Re: Review of AEM's 2021 Annual report for Hope Bay Project.

Cambridge Bay Ikaluktutiak Dear Richard Dwyer, the KIA has reviewed AEM's 2021 Annual Report for the Hope Bay project to the NWB.

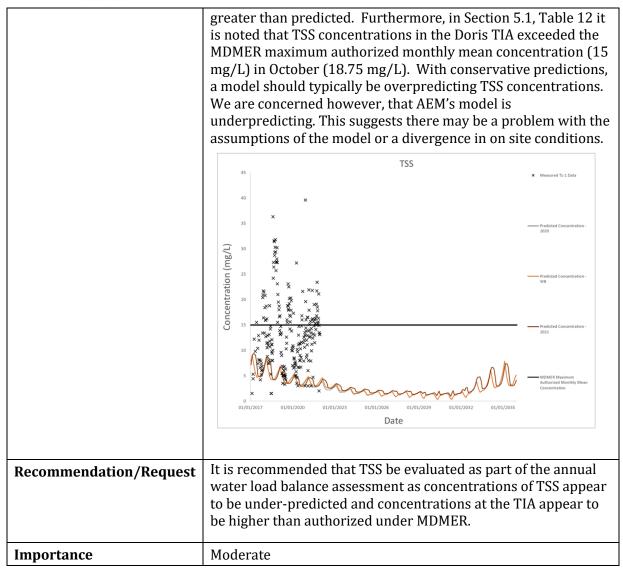
Review Comment Number	KIA-NWB-25
Subject/Topic	Doris Sedimentation Pond
References	Hope Bay Project 2020 Kitikmeot Inuit Association Annual Report.
	Appendix D Water Licence(s) Monitoring Data Appendix D.1. 2AM-DOH1335
Summary	Table D1-1 indicates that sampling at SNP station ST-1 is collected annually.
Detailed Review Comment	It is important that regular sampling of water that is transferred from ST-1 to the TIA from June to October is monitored on a monthly basis.
	Table D1-1 indicates that samples are collected from ST-1 annually, however water is transferred from ST1-1 to the TIA from June to October of any given year. Therefore, sampling should be completed to be representative of the entire transfer period to ensure it is meeting the influent water quality requirements of the water treatment plant.
Recommendation/Request	It is recommended that AEM complete monthly sampling while discharging to the TIA.

Table 7: Initial Screening Assessment of Water and Load Balance Parameters

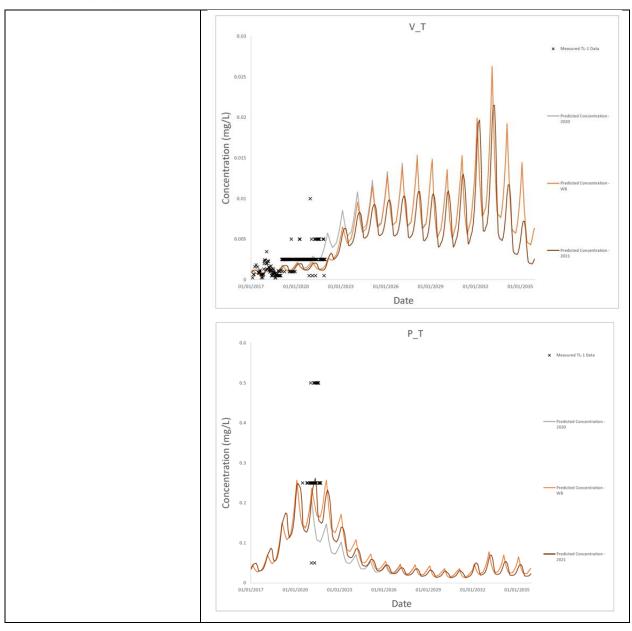
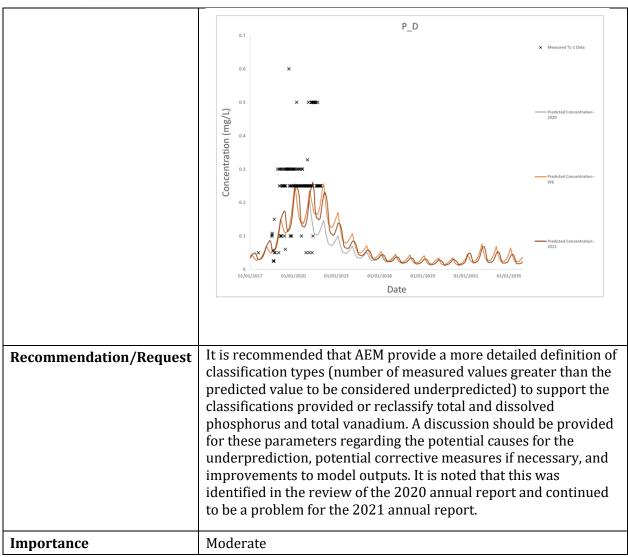
Review Comment Number	KIA-NWB-28
Subject/Topic	Misclassification of Water Quality Parameters
References	Hope Bay Project 2021 Nunavut Water Board Annual Report
	Appendix E. Doris Mine Annual Water and Load Balance Assessment – 2021 Calendar Year
	Section 1 Introduction
	Section 2.2 Review of Water Quality Inputs
	Attachment 2 Annual WLB Assessment – 2021 - PLOTS
	Hope Bay Project 2020 Nunavut Water Board Annual Report

Appendix E. Doris Mine Annual Water and Load Balance Assessment – 2020 Calendar Year
	Section 1 Introduction
	Section 2.2 Review of Water Quality Inputs
	Attachment 2 Annual WLB Assessment – 2020 - PLOTS
Summary	Several measured concentrations of total and dissolved phosphorus and total vanadium were greater than predicted concentrations in both 2020 and 2021. However, these values were considered conservative (measured values below model predictions), no efforts were made to explain the discrepancy between measured and predicted results and no efforts were made to correct the model predictions.
Detailed Review Comment	Underpredicting concentrations of several metals indicates that the model predictions are not accurate. This was noted in review comments of the 2020 annual report as well as noted in the review of the 2021 annual report.
	AEM states, "After the water balance (quantity or volume) adjustment, the model was assessed from a water quality perspective. Parameters were grouped based on the comparison of predicted and observed results for the Doris TIA. The following parameter groups were previously identified Conservative predictions (measured values below the model predictions),

Predictions trending well with measured data, Underpredicted, and, Detection limit greater than prediction (i.e. below testing detection)
	The model was considered adequate for the parameters where predictions were conservative (overestimated in the model), trending well with measured data, and where detection limits were greater than prediction. Underpredicted values were assessed individually and adjusted based on measured observations in the process water, mine water and the Doris TIA."
	According to Section 2.2, Table 7 in the 2021 report: Initial Screening Assessment of Water Load Balance Parameters (reproduced below), concentrations of total and dissolved phosphorus, and total vanadium were all categorized indicating "measured values are below model predictions". Plots presented in Attachment 2 of the Annual Water Load and Balance Assessment show a large number of measured values above the predicted concentration line. Parameters that were considered underpredicted were carried forward in the assessment and a

discussion of corrective actions provided. Since total and dissolved phosphorus, and total vanadium were not classified as underpredicted, they were not carried forward in the analysis and no corrective actions were discussed for the greater than predicted concentrations. It is recommended that AEM provide a more detailed definition of classification types (number of measured values greater than the predicted value to be considered underpredicted) to support the classifications provided, indicate if the detection limit is greater than prediction for these parameters or reclassify total and dissolved phosphorus and total vanadium. A discussion should be provided for these parameters regarding the potential causes for the underprediction, potential corrective measures if necessary, and improvements to model outputs.
